8 May 2019

WM Project Number: 13385
Our Ref: KY 080519 Mod BC.docx

Re: Operational Noise statement for S4.55(2) Application - Crown Sydney

Figure 2 Level 3 All Day Dining Proposed Modification Plan

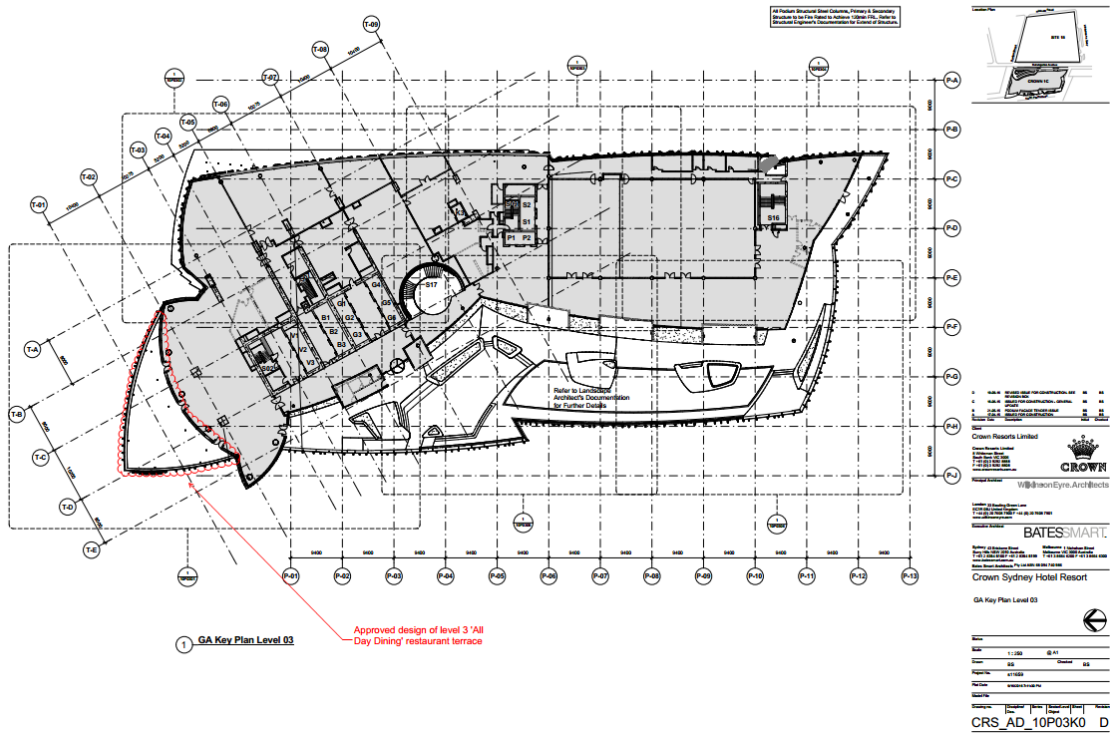
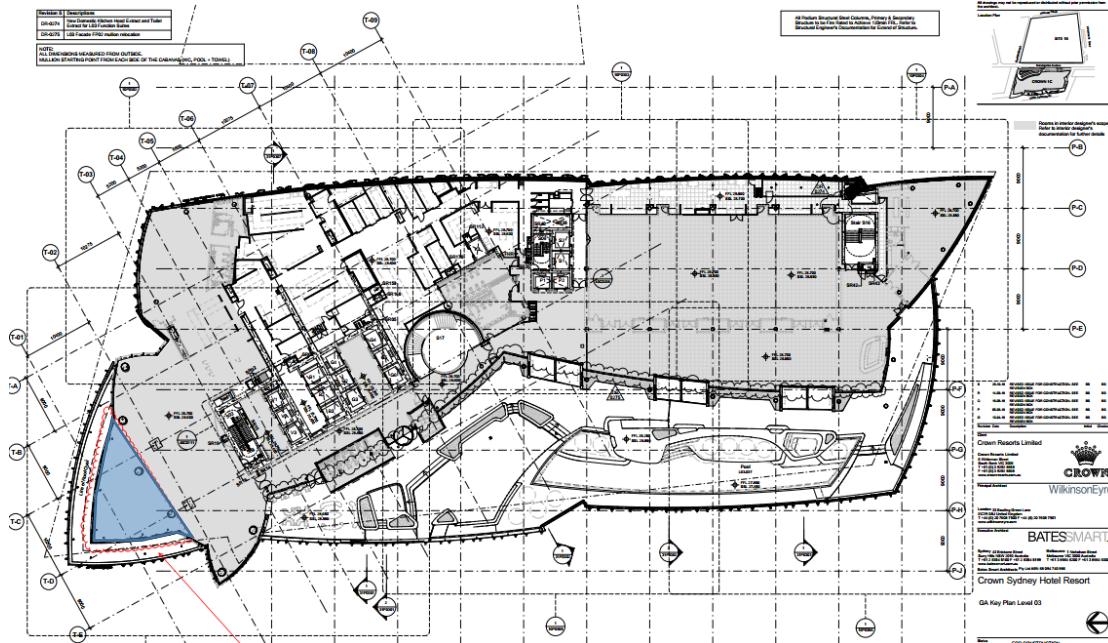
1. Moving of the façade line at the level 3 All Day Dining restaurant terrace to partially enclose the area.
2. Partial enclosure of the Spa terrace at level 4.

A review of the two areas indicates that the outdoors areas will be now enclosed. As such noise generated by patrons and activities in these areas will now be contained within the building envelope. As such the noise contribution from these areas to surrounding noise sensitive receivers, as detailed in our assessment, will be significantly reduced.

Therefore the proposed changes will not adversely impact on the acoustic amenity of surrounding noise sensitive receivers. That is, from a noise perspective, the proposed modification are acceptable.

Further it is noted that as these areas are now enclosed any restrictions on hours of operation as identified in the DA Acoustic report in Table 6-4 (See attached) are no longer necessary.
